ETE Road Map

High Energy Pipe Lines at 28,8 m Level

Final Monitoring Report

Report to the Federal Ministry of Agriculture,
Forestry, Environment and Water Management
of Austria

Figure 3: Temelín NPP – the main steam and feed water lines inside and outside the containment (at 28,8 m level)

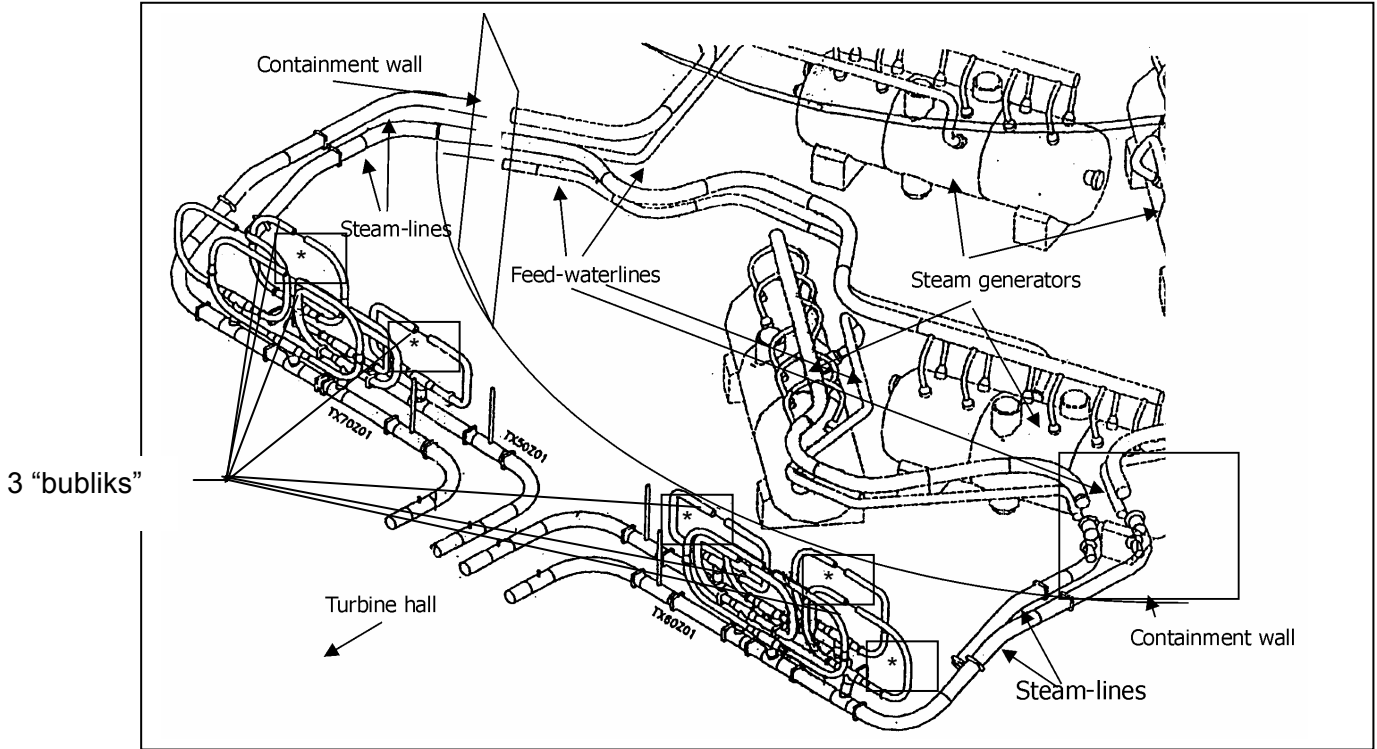
- Confirmation of correct location and design of pipe whip restraints, with circumferential welds covered by the pipe whip restraints inspected by qualified ultrasonic testing (UT) procedures in accordance with the European Network on Inspection Qualification (ENIQ).
- Application of the break exclusion principle to the pipelines from the containment penetration to the first isolation valves outside containment, including a requirement for 100% volumetric qualified UT examinations for all welds in the high energy piping system from the containment penetrations to the first isolation valves (see ANNEX C, Figure 3).

The main steam piping in each of the four main steam lines has three branch sections "bubliks" connected via T-joints (see ANNEX C, Figure 3), which are piping segments from the main steam line to the BRU-A and MSSVs. These "bubliks", as stated by the presenters, are not part of the break exclusion concept and have not undergone structure analysis.

Fig. 1

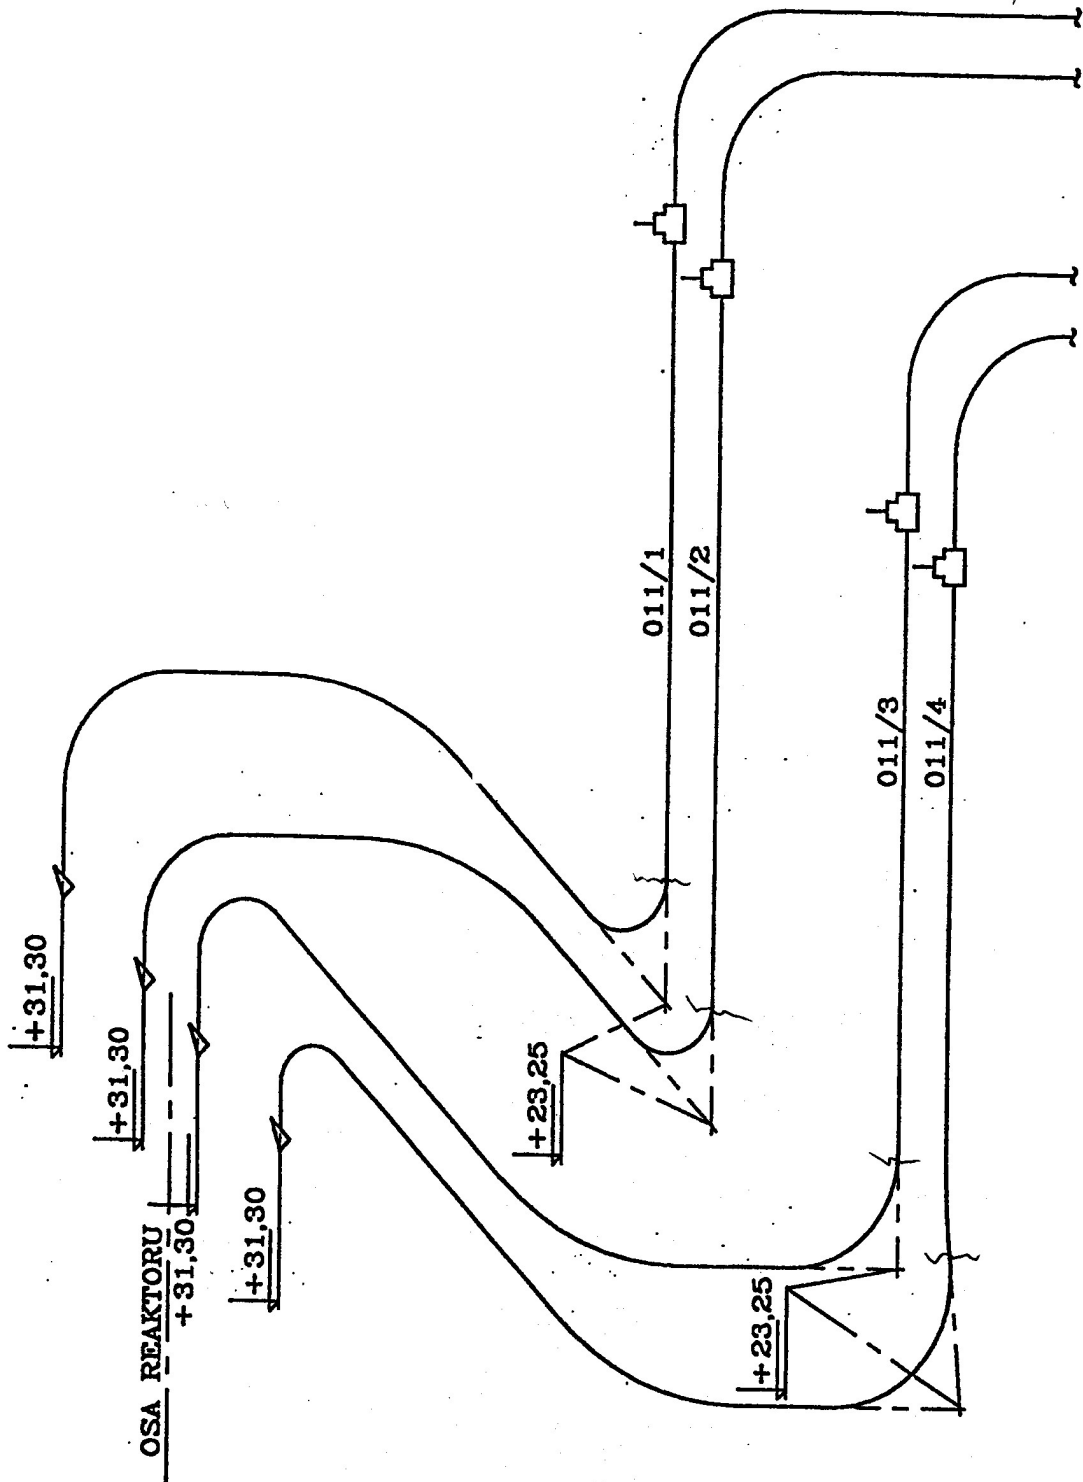
According our opinion, the worst case is the break postulation in the elbows on the floor +23,25 m, see Fig. 1 and 2. For the analysis of wall-piping impact using of such computer code as PAM-CRASH is advantage. Can you inform us about the methodology of KEDs Finite Element calculations ? Second question: what do you mean under word “damage”? Is it scabbing or spalling? According to our very simple calculations perforation is impossible.

- ad 1) In Fig. 1 are not indicated valves. It is only top view on the run $\varnothing 630 \times 25$ and the T joints to bubliks;
- ad 2) In the steam lines between SG and machine hall are not flow limiters;
- ad 3) Yes, we confirm this parameters. But have in mind that design parameters are higher;
- ad 4) Swing check valves with disk position indicator DN 400 PN160, $p_p - 8.6$ MPa, type A 42 127 – 4160 – 400 minimal internal diameter 320 mm, welded into piping $\varnothing 426 \times 24$, too in series, body of austenitic steel (forged + welded). (TX 41, 42, 43, 44 S03, S04) – main feedwater piping L = 1010 mm;
- ad 5) The wall thicknesses are illustrated in enclosed Figure;
- ad 6) Inside machine hall on the vertical wall are not installed pipe whip restraints.
